SERVICE BULLETIN

Subject: TS45 Mux Units Pin Changing and Diode Checking Bulletin

Bulletin No: TS45-SR-2502

This bulletin aims to check and solve Mux 06A033 and 06A037 issues.

Figure 1.2 – Revised Diagram for Figure 1.1

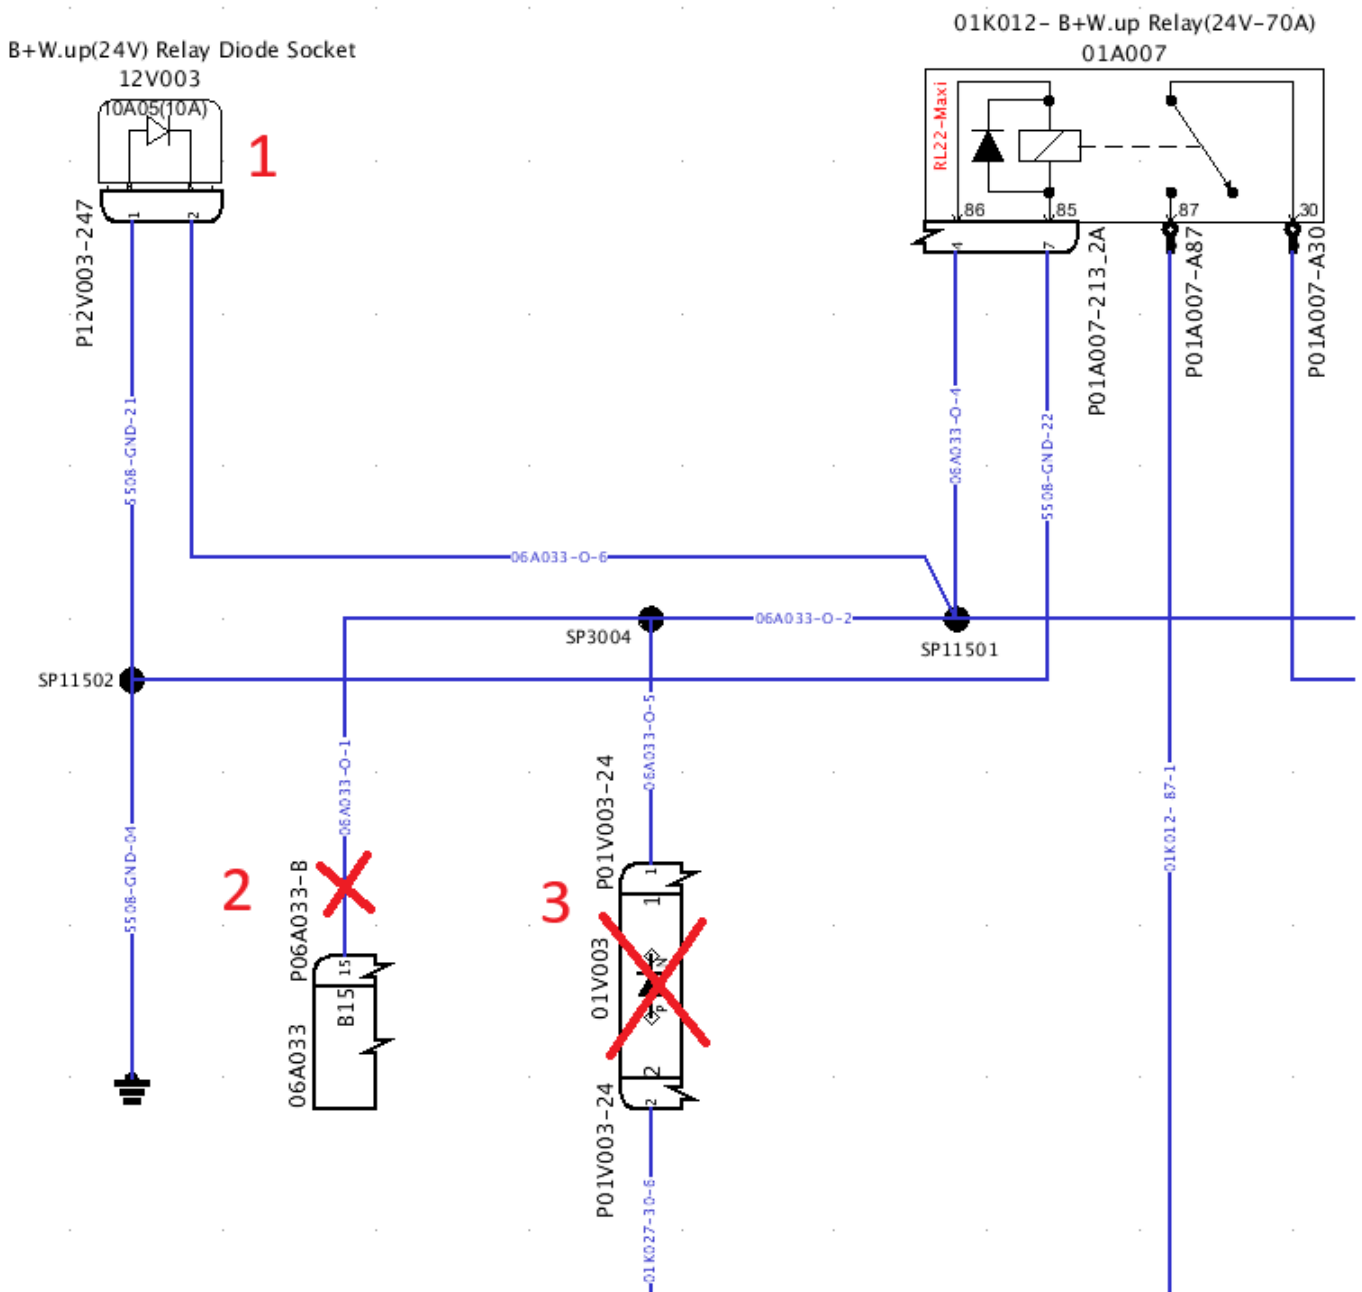
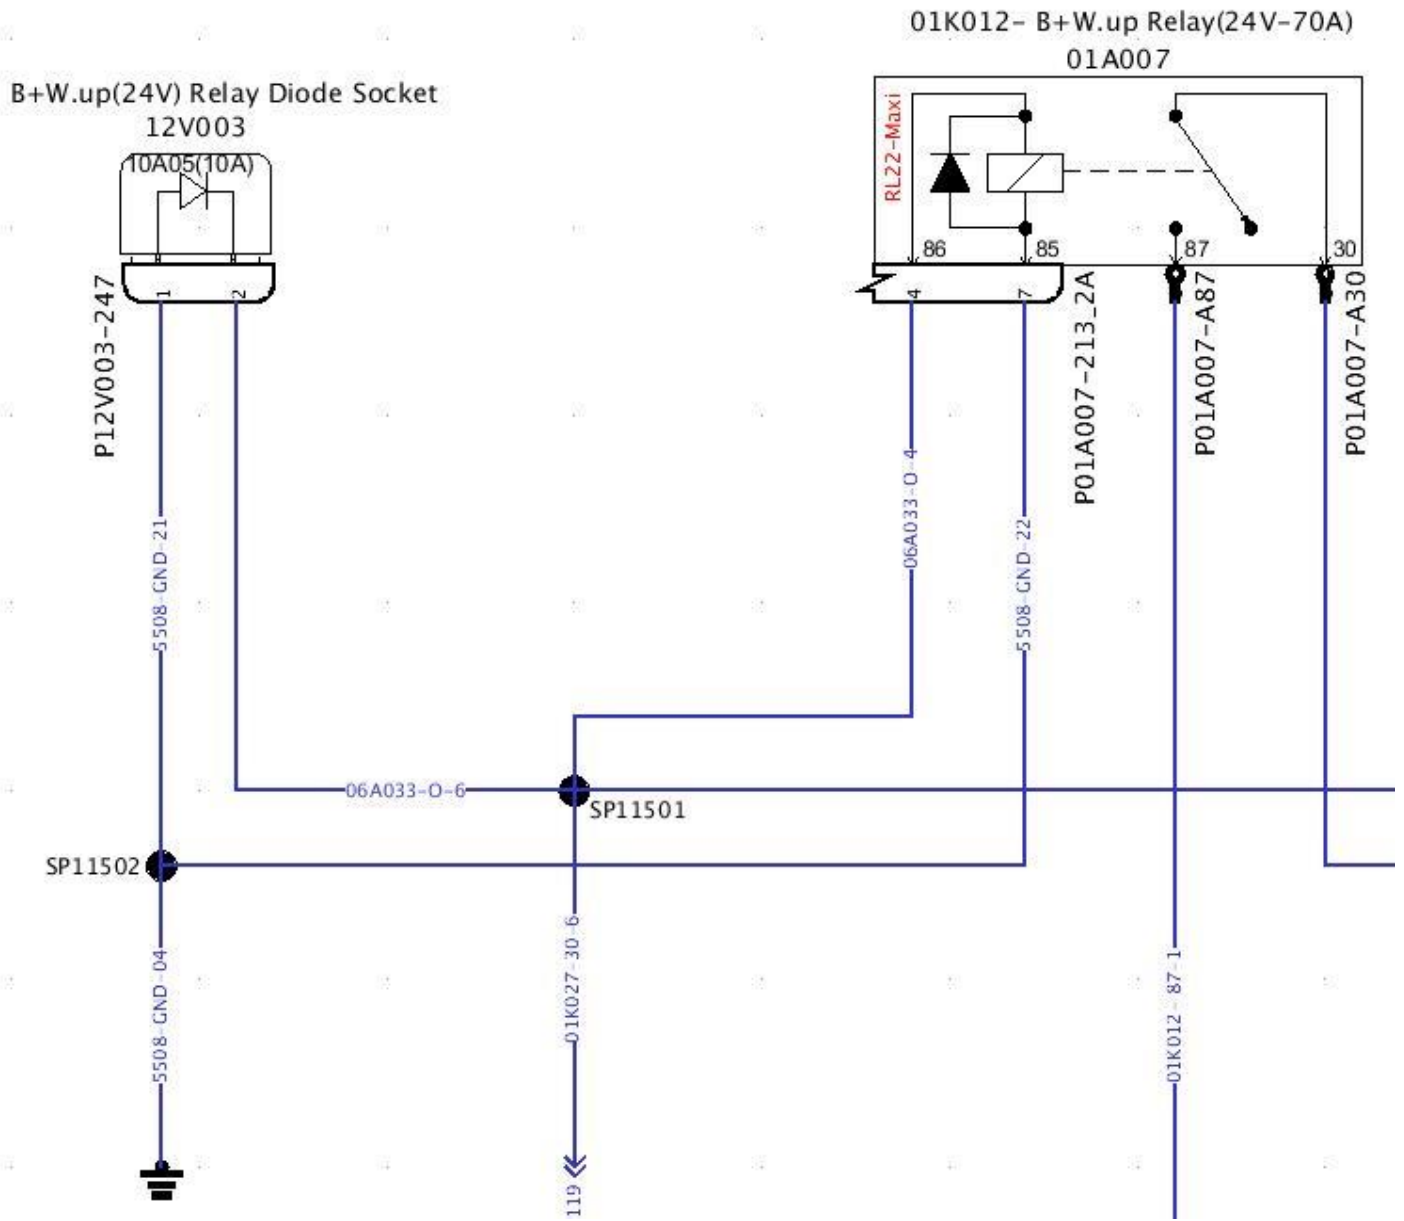
2.) Step 1: Check the diode on the “P12V003-247” socket. If there is no diode on this pin, you should add the diode that in the part list , as “Figure 1.1”.

If there is a diode, then check the diode polarity and make sure that this is good and working properly. If this diode is damaged, replace it.

Step 2: Remove the cable on pin **B15** in the P06A033-B socket on the front relay panel. Blind and insulate the removed cable with electrical tape “Figure 1.1”

Step 3: Remove “P01V003-24” diode. Then join the cables “01K027-30-6” and “0A6033-0-5” each other. **Use solder for joining wires.** Then make sure that there is a good joint and insulate joint with electrical tape.

The implementation must match the Figure 1.2.

Figure -2- Moving B16 pin to B24

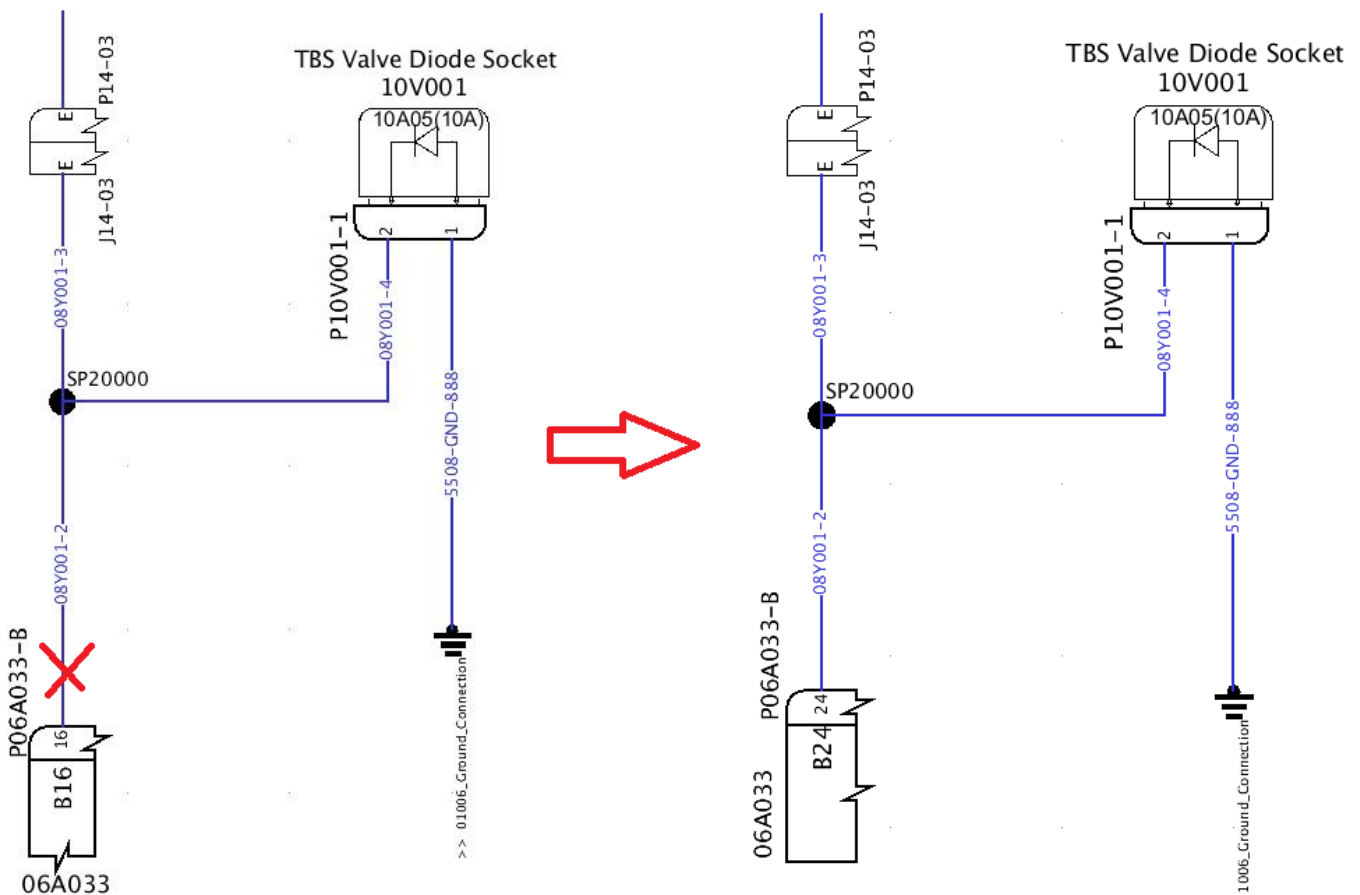
3.) Remove the cable “08Y001-2” cable from front relay panel P06A033-B pin **B16**, cut the its terminal from wire then crimp the new terminal “9402-158Y”. Connect this cable to P06A033-B pin “**B24**” in Figure 2.

Then check the diode on the “10V001” socket. If there is no diode on this pin, you should add the diode that in the part list , as “**Figure 2**”.

If there is a diode, then check the diode polarity and make sure that this is good and working properly. If this diode is damaged, replace it.

Figure-3.2-Revised Diagram for Figure 3.1

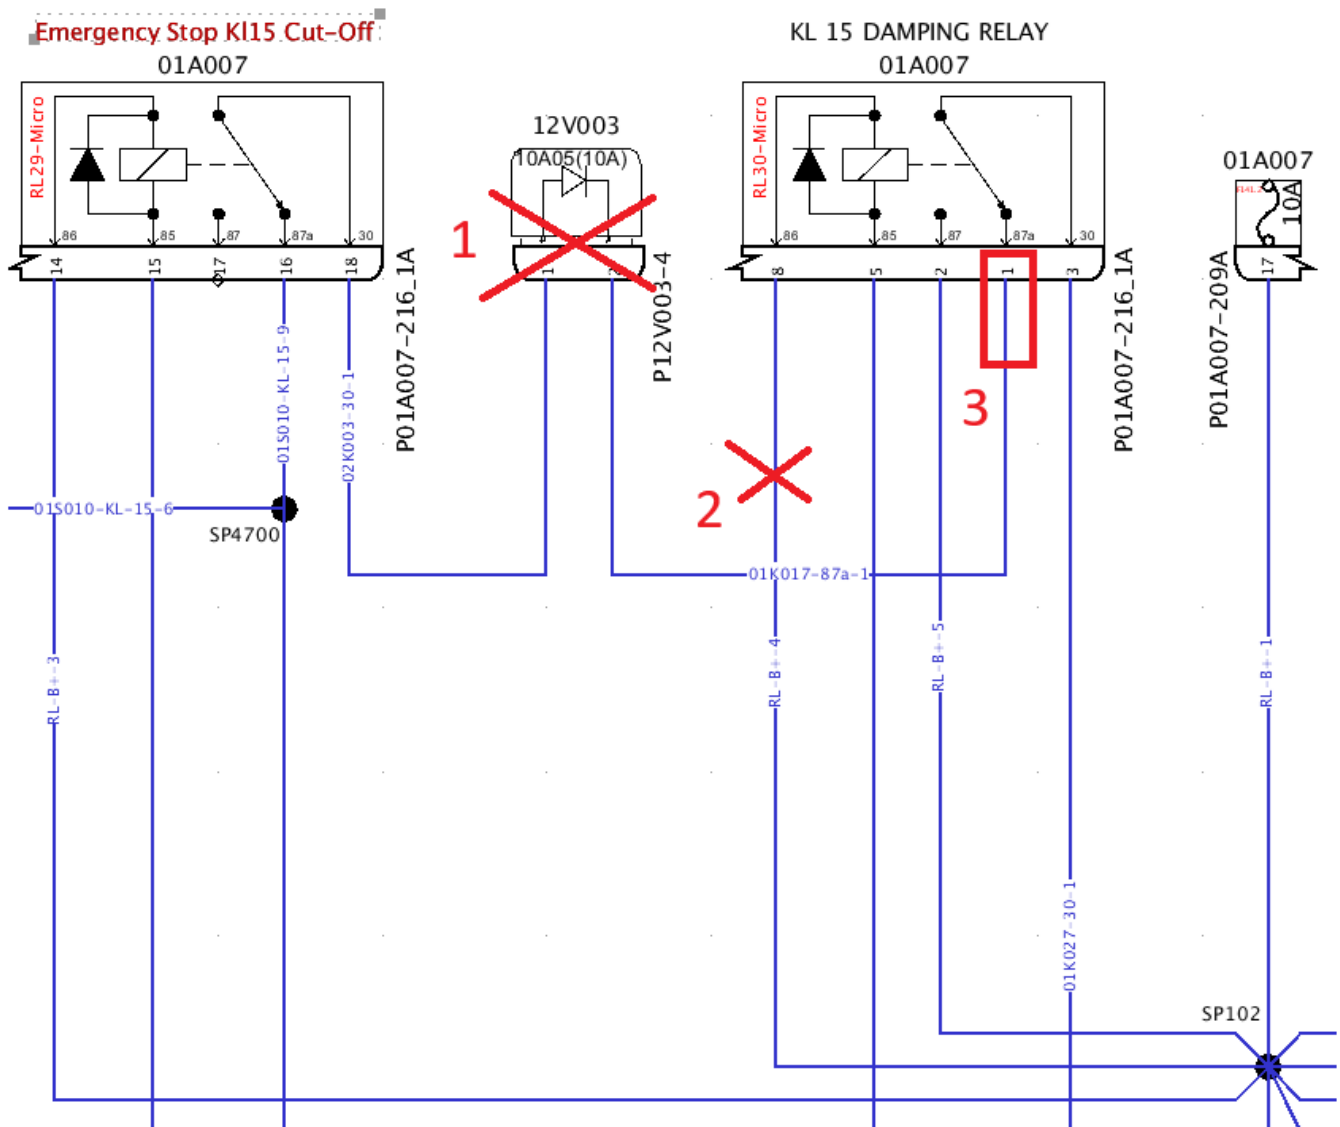
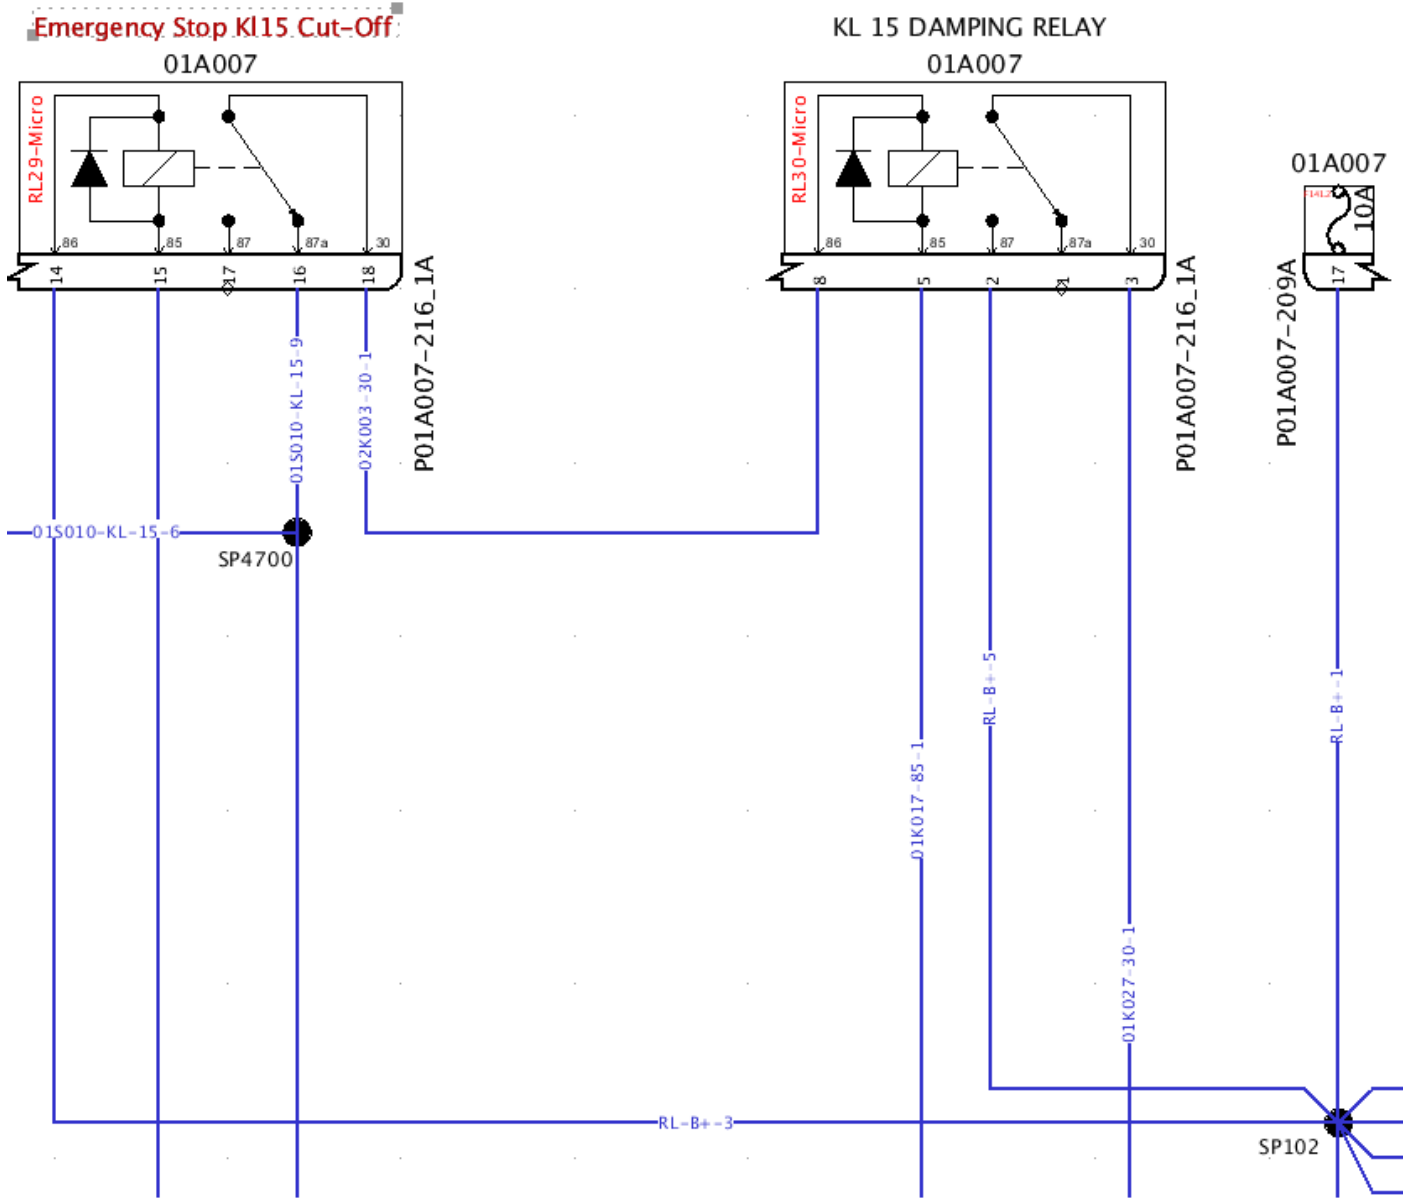
3-) Step 1: At front relay panel, remove the **P12V003-4** diode and join the “**02K003-30-1**” cable and “**01K017-87a-1**” cable each other. Use solder for joining wires. Then make sure that there is a good joint and insulate joint with electrical tape.

Step 2: Find “**P01A007-216-1A**” socket from the front relay panel, remove the “**RL-B+-4**” cable from pin8 . Then blind and insulate the removed cable with electrical tape.

Step 3: Remove “**01K017-87a-1**” cable from pin1 of “**P01A007-216-1A**” socket then connect it to pin8.

The implementation must match “Figure 3.2”

Figure-4-

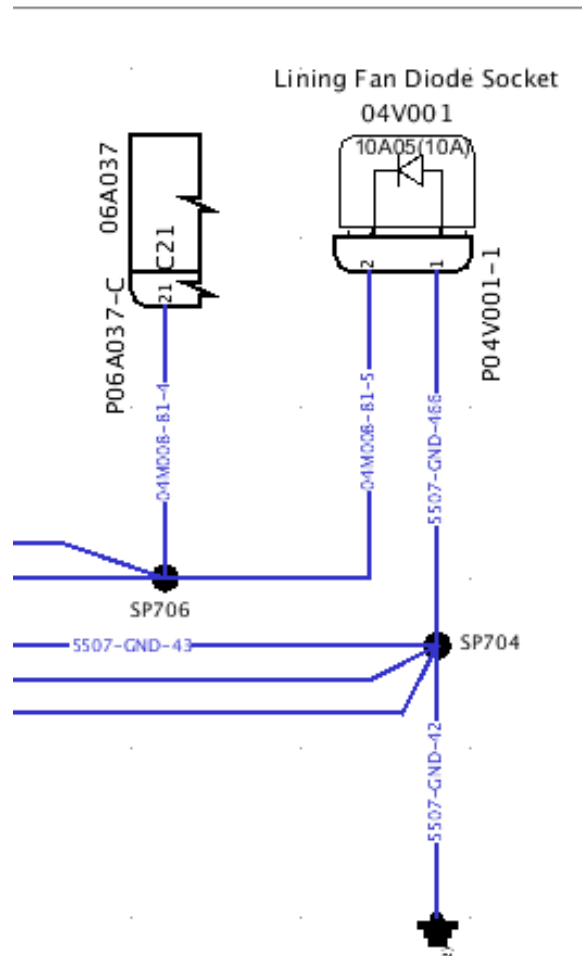
5.) Check the pin C21 on the P06A037-C socket on the rear relay panel. If there is no diode on this pin, you should add the diode that in the part list as **“Figure 4 ”**.

If there is a diode, then check the diode polarity and make sure that this is good and working properly. If this diode is damaged replace it.
